Technical Bulletin

Model: Bridge Unit BU5000 (D379)				ate: 23-Jan-12		No.: RD379001		
Subject: Part Changes; Handle assembly and Shoe				Prepared by: A. Takada				
From: PP Tech Service Dept., 1st PP Tech Service Sect.								
Classification:	Troubleshooting	 ☑ Part informati ☑ Electrical ☑ Transmit/rece 		ion Action required				
	Mechanical				Servic	e manual revision		
	Paper path			eive 🗌 Retro		fit information		
	Product Safety	Other ()	Tier 2

Change: Shape of the Handle assembly and Shoe

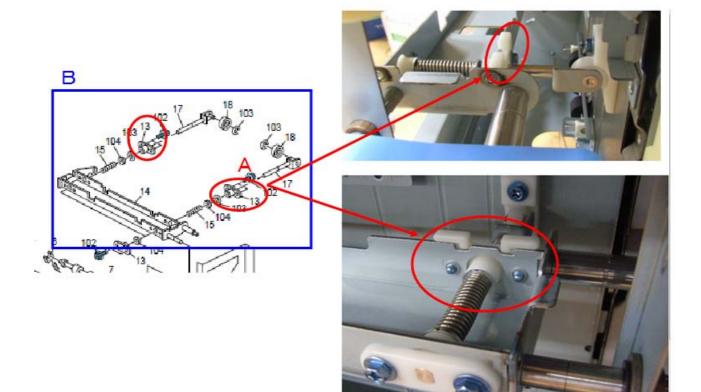
Reason: To enable usage of common parts with different products

A : Shoe: Handle: Release

Shape of the Shoe was partially modified.

B : Handle: Ass'y

Handle was also modified in accordance with the shape change of the Shoe. (Shape of the plate was also modified.)

If the unit is now installed with D3553566, replace with D3553567. D5163847 is not needed.

• D5163847 can be attached ONLY to D3553567.
